SUBJ: Cedar Hill Road Subdivision (1512-1524 Cedar Hill)-#25-07SUBD

Reference: 1512 & 1524 Cedar Hill Road Subdivision
TMP's #39-00-00646-00-8 and #39-00-00649-00-5
Preliminary/Final Land Development Application

Pursuant to your request, Gilmore & Associates, Inc. performed a review of the preliminary submission for land development for the above-referenced project. Upon review, we offer the following comments for consideration by the Lower Gwynedd Township Board of Supervisors:

NO.	DESCRIPTION	DATE
3	ADM. REVISED PER VARIOUS REVIEWS	FEB. 27, 2026
2	ADM. REVISED PER VARIOUS REVIEWS	NOV. 20, 2025
1	M.F.P. S.T.A. PLAN ORIGINATOR DATE	AUG. 25, 2025

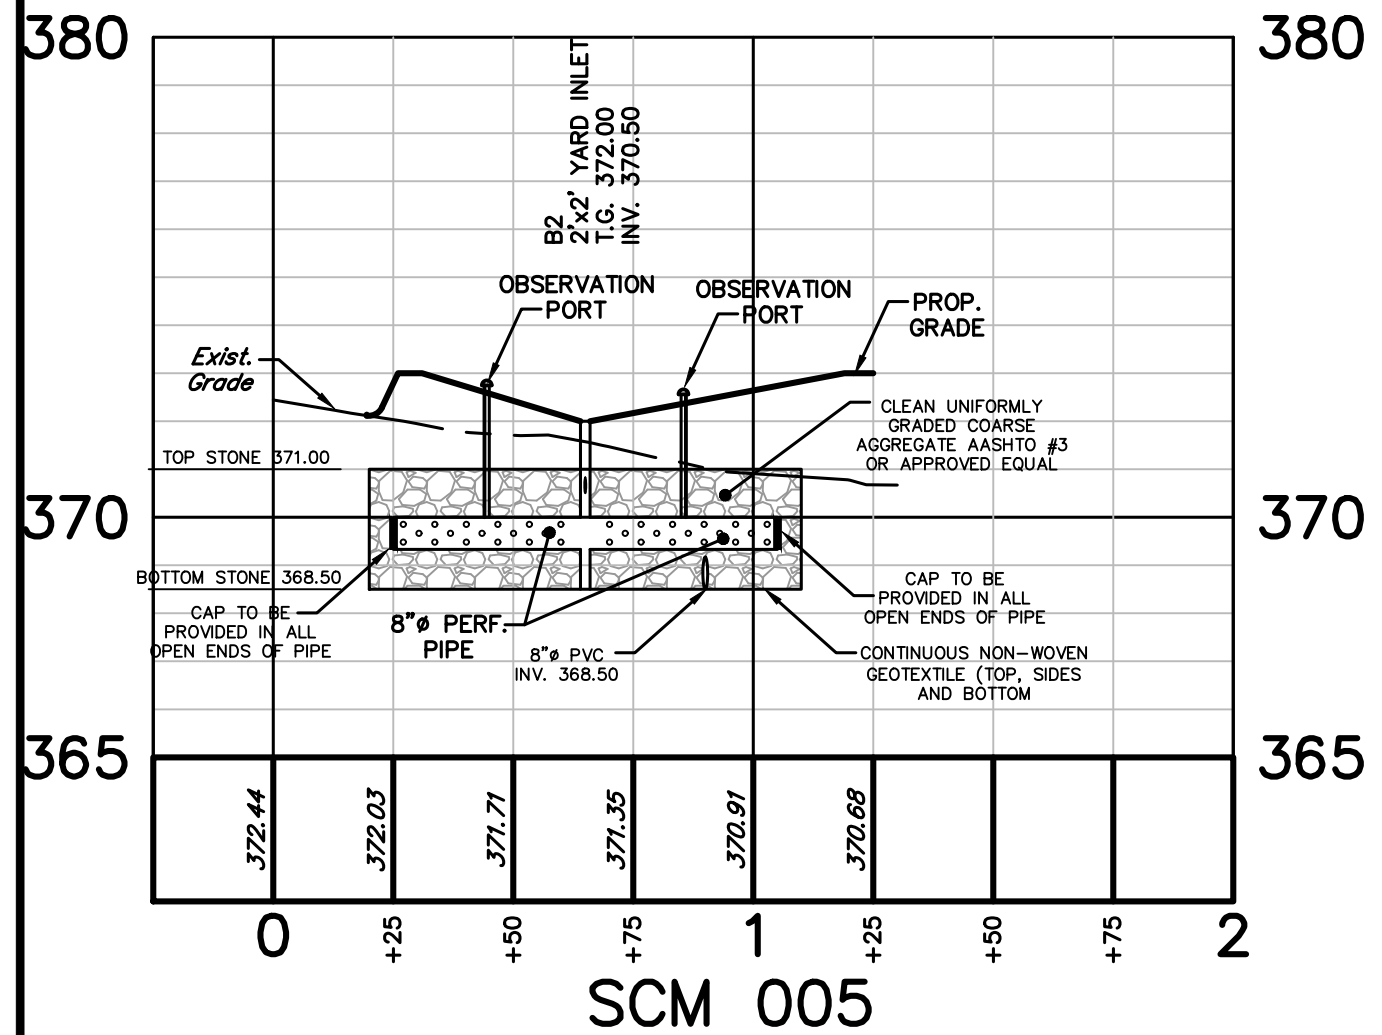
- f. The PCSM Plan (sheet 9 of 18) shall be revised so that the callout text does not overlap other linetypes for clarity.
 - g. The widths of SCM 005 & SCM 007 on the PCSM Plan (sheet 9 of 18) is not consistent with the callout and details. The Applicant shall confirm the sizes and revised the plans accordingly.

PLAN SCALE	DRAFTED BY	PROJECT MANAGER	PLAN SHEET NUMBER
HORIZONTAL: 1" = 40'	M.J.P.	S.A.R.	14 OF 18
VERTICAL: 1" = 4'	PROJECT NUMBER	DRAWING FILE NUMBER	
	6571	6571RD

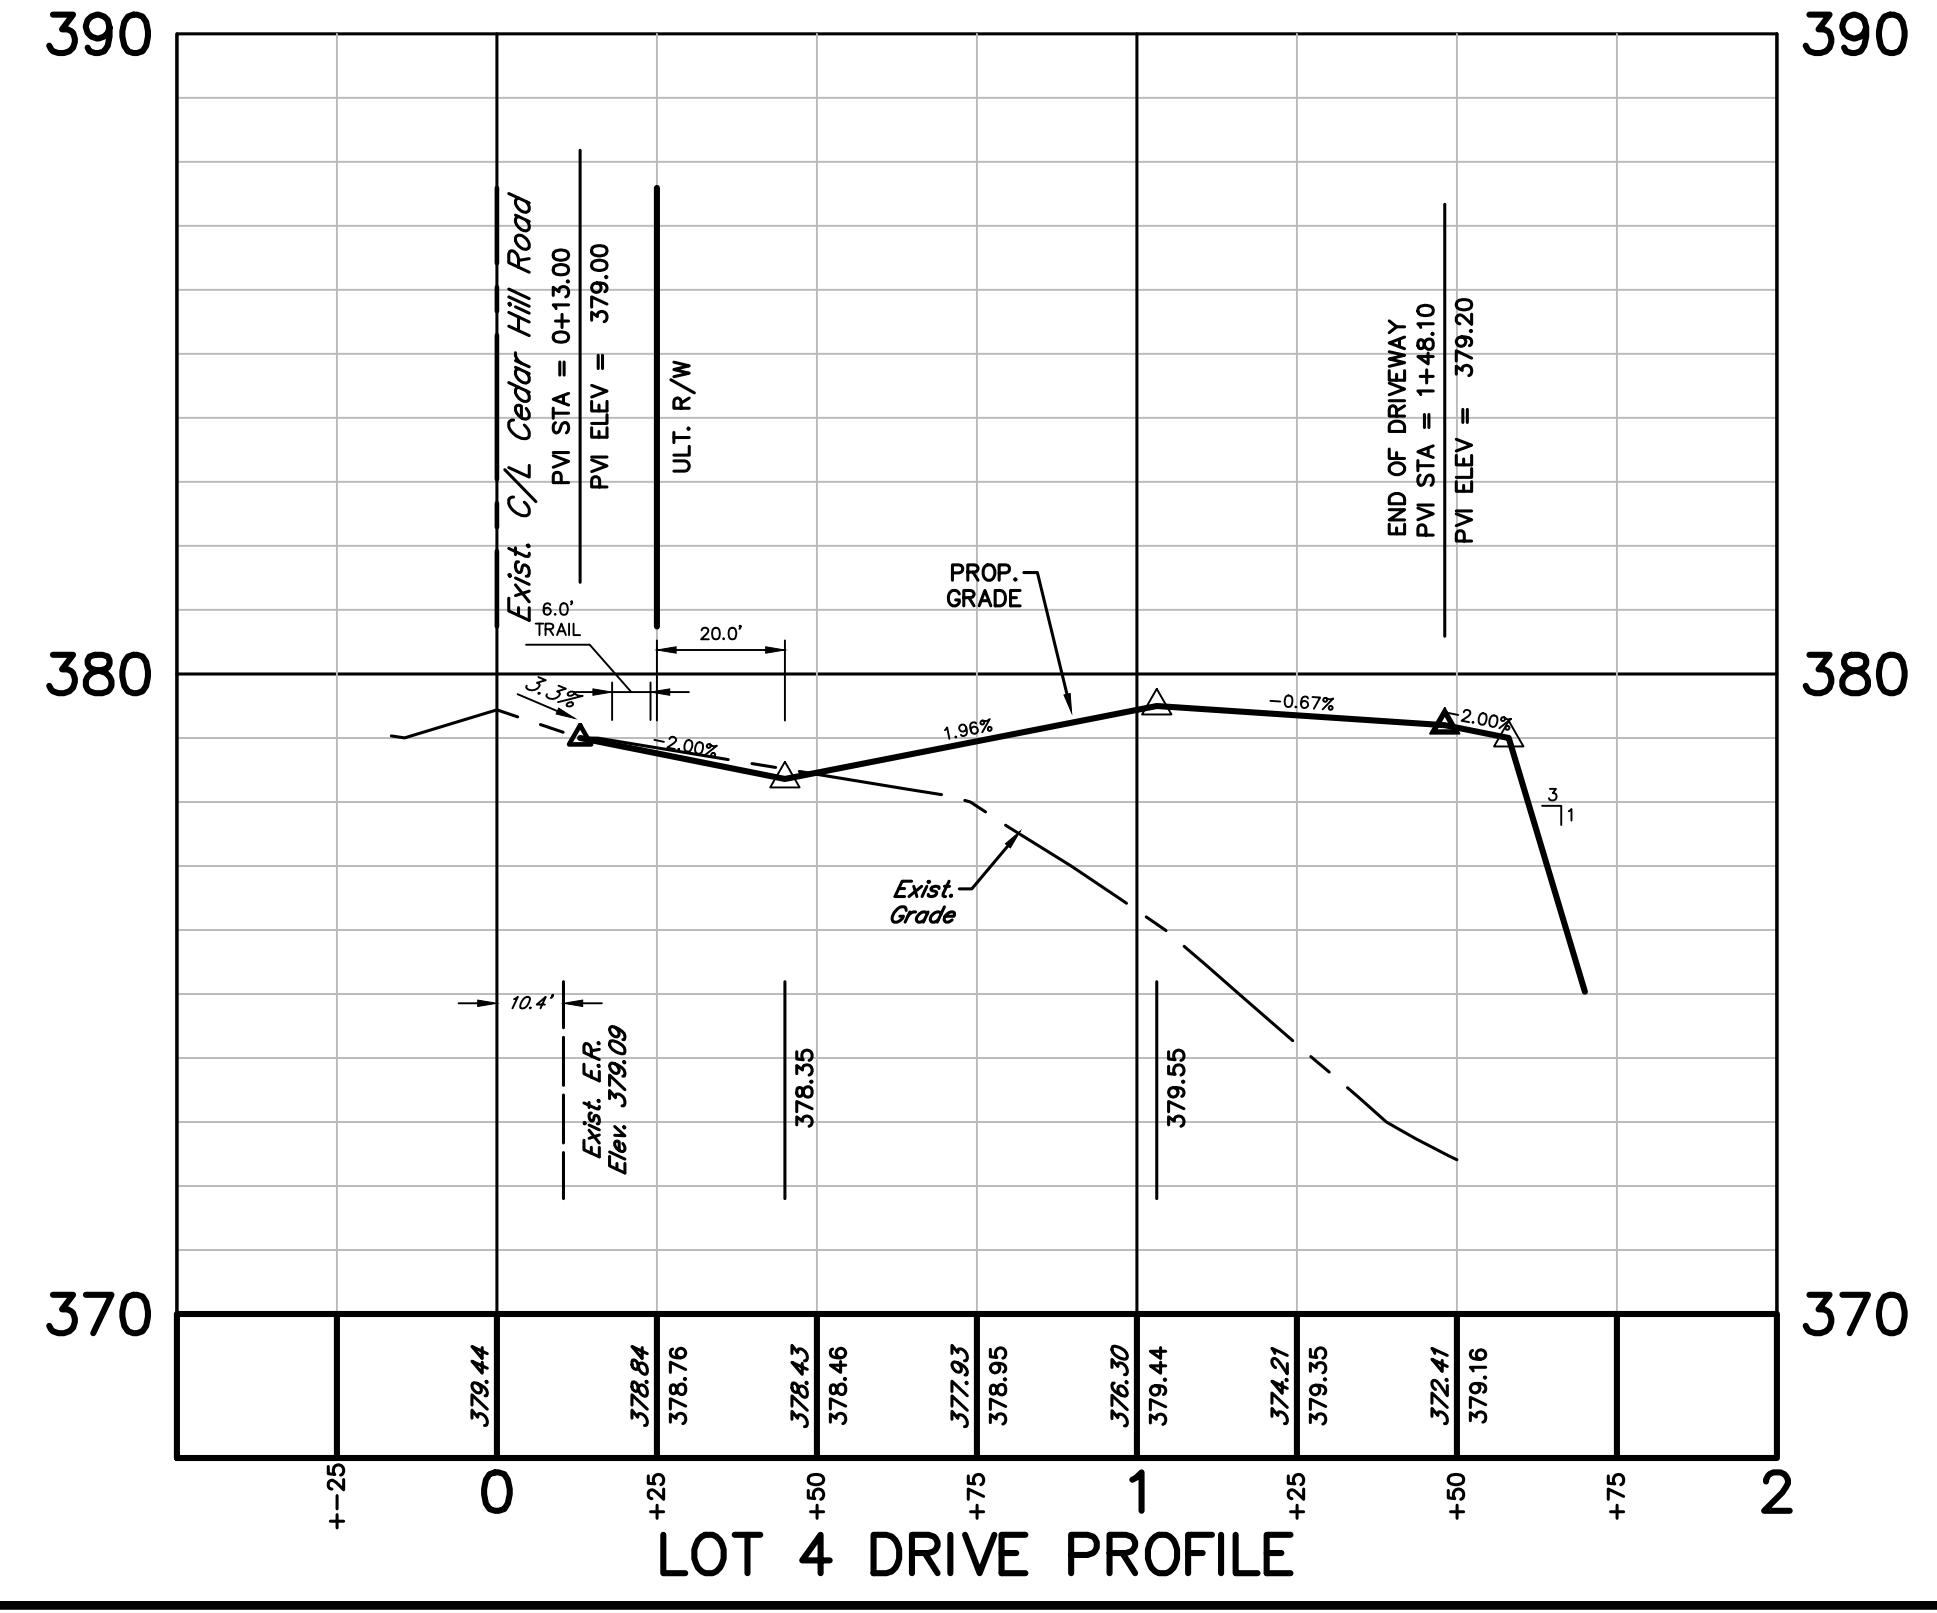
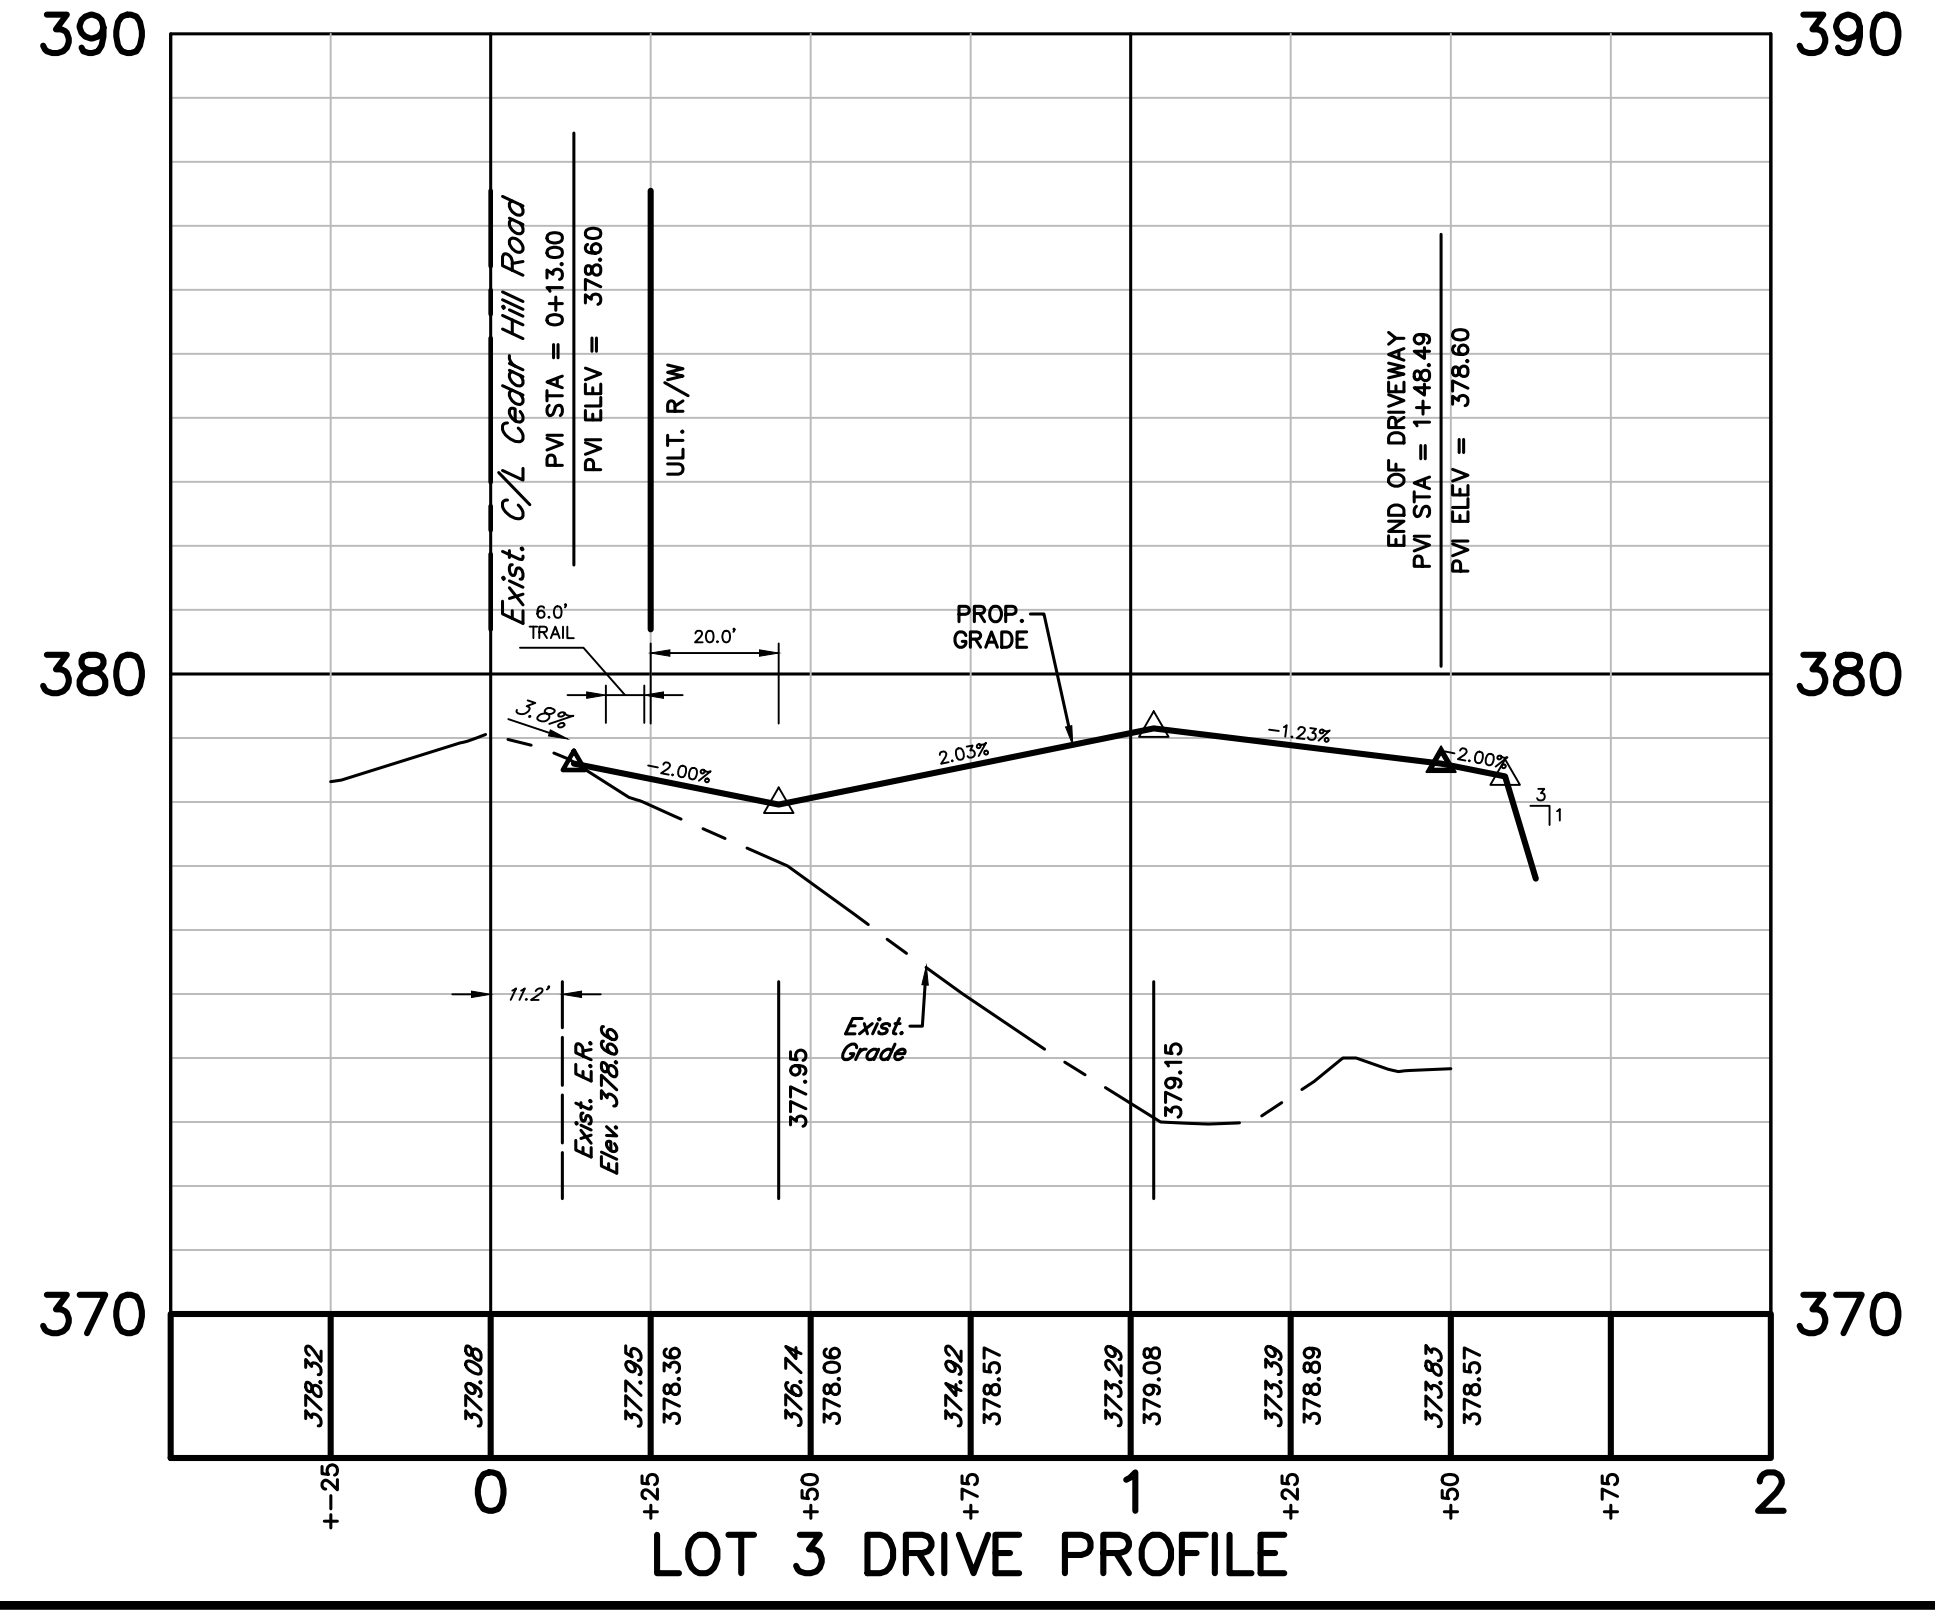
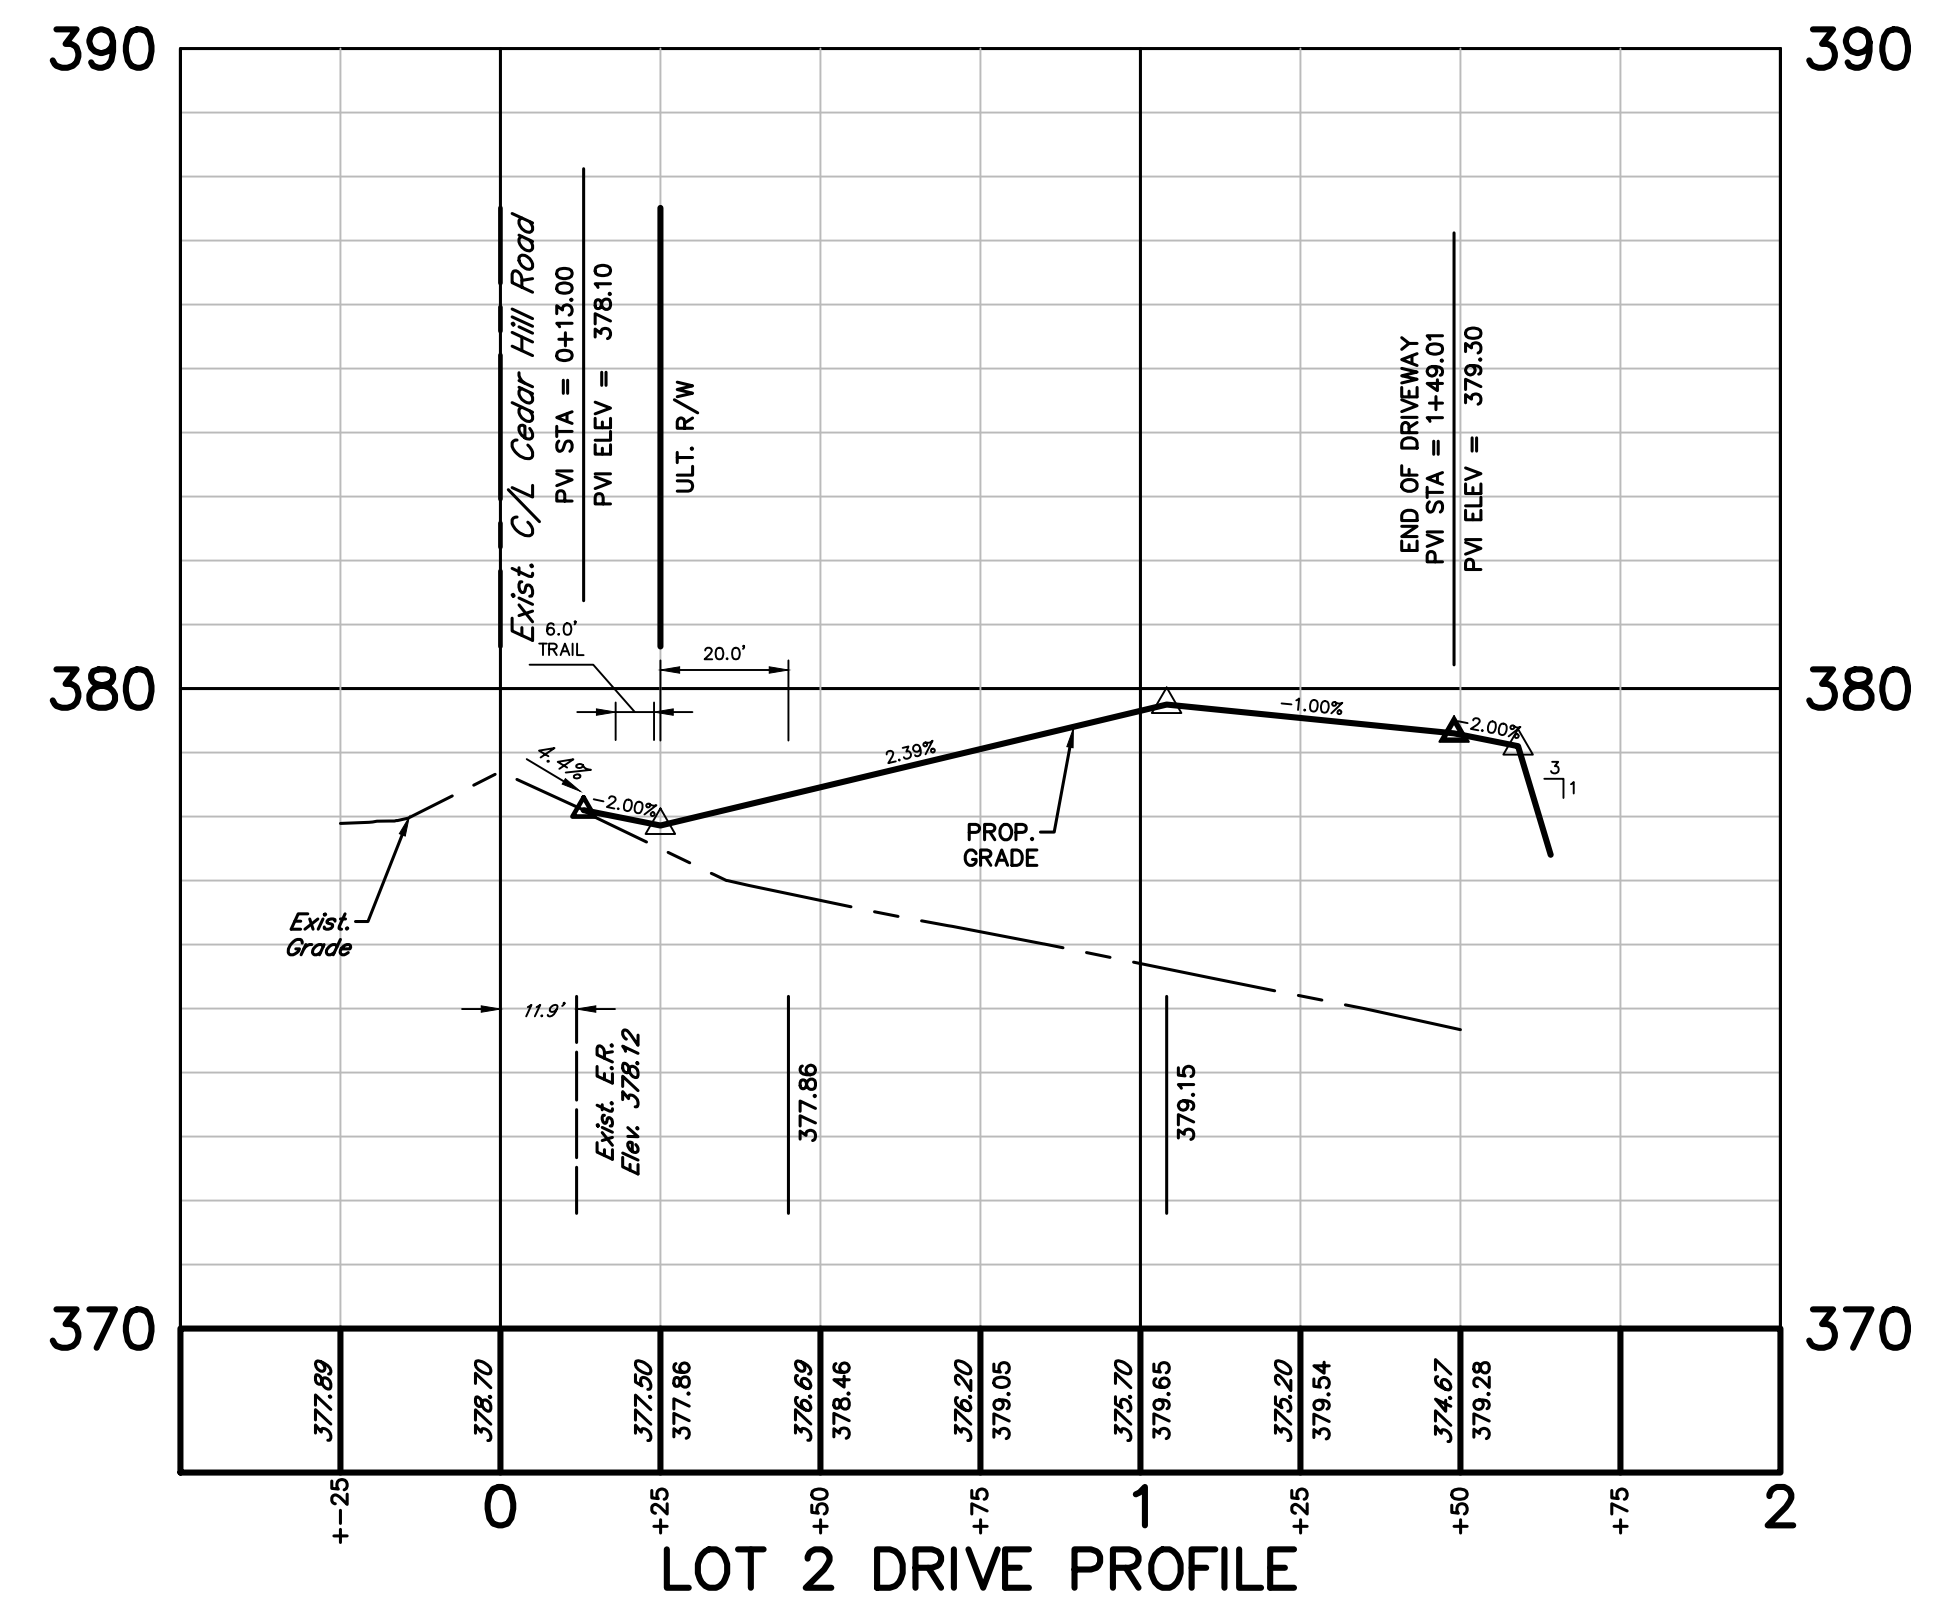
5. The details provided on Sheet 14 of the plan set appear to have a discrepancy in regards to the grass strip width between the edge of pavement and the proposed paved trail. The designer should evaluate and revise as necessary, and the buffer strip should be in accordance with **Section 1230-45** of the **Subdivision and Land Development Ordinance**.

Response: The details on Sheet 14 have been corrected to be consistent and now show a 5 ft. wide grass strip which exceeds the minimum required 4 ft. grass strip in §1230-45.
